SUBJECT: PORT'S COMMENTS ON CHEMPRO DRAFT RFI WORKPLAN.

Figure A-4.
CHEMPRO PIER 91 FACILITY
SOURCES IN PATHWAYS ANALYSIS

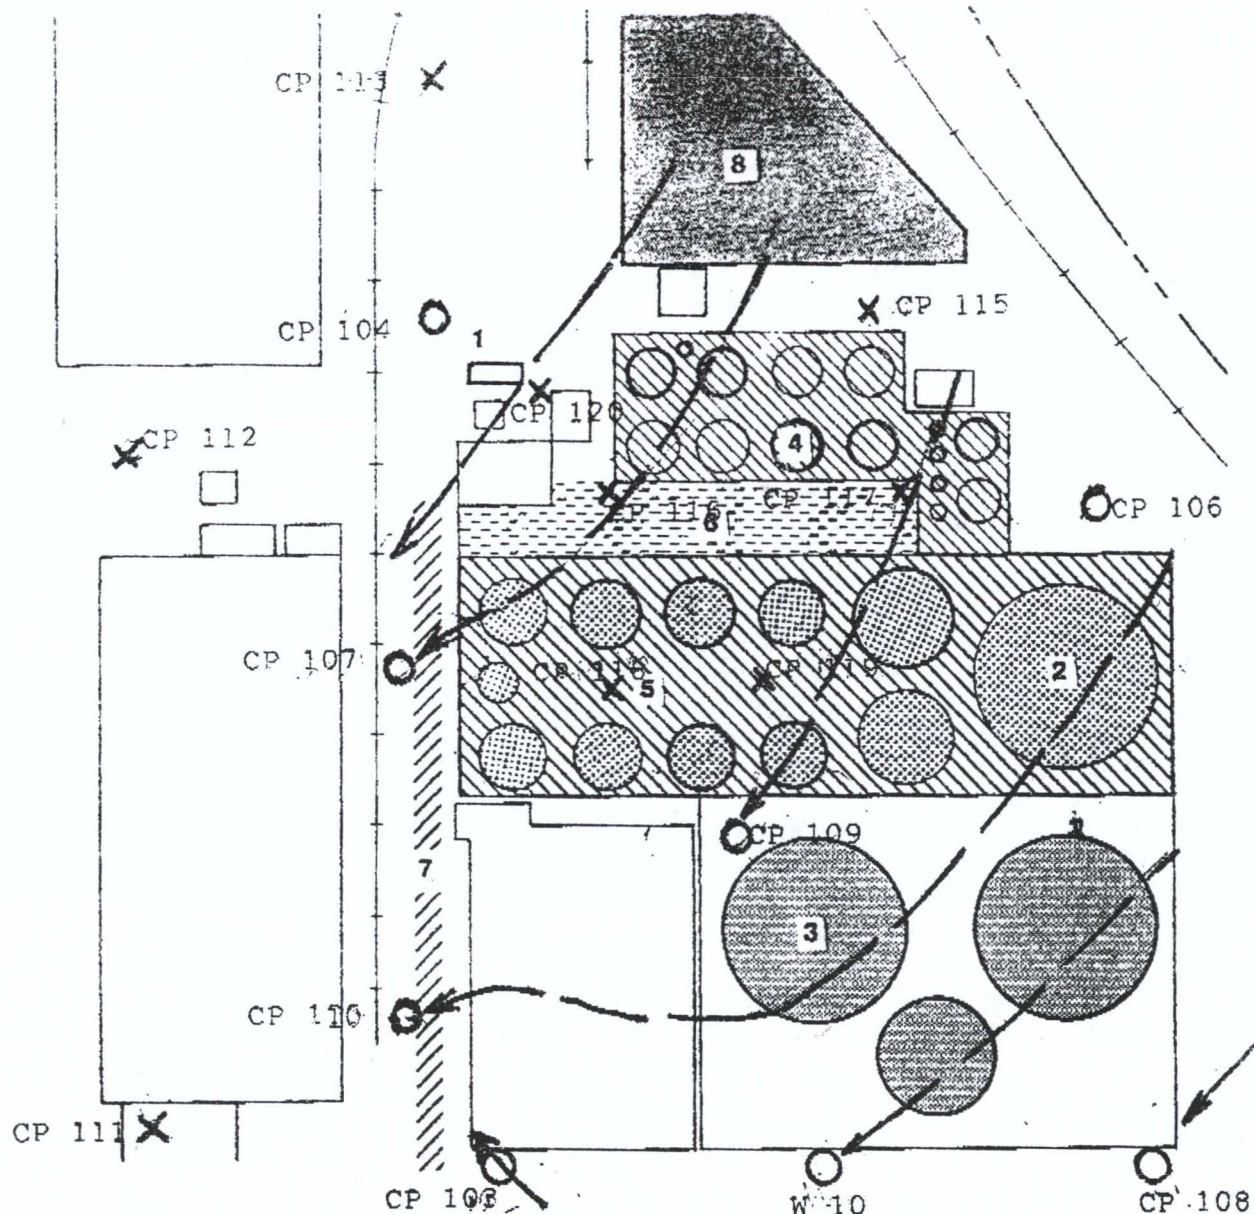
The attached map shows the flowpaths taken from the ground water contour map submitted as part of my review of the Draft work plan. The existing wells are indicated by Os. The Xs are for the proposed new borings. This map and the indicated flowpaths will aid us when we discuss the Port's comments about the locations of ground water monitoring wells for the upper aquifer.
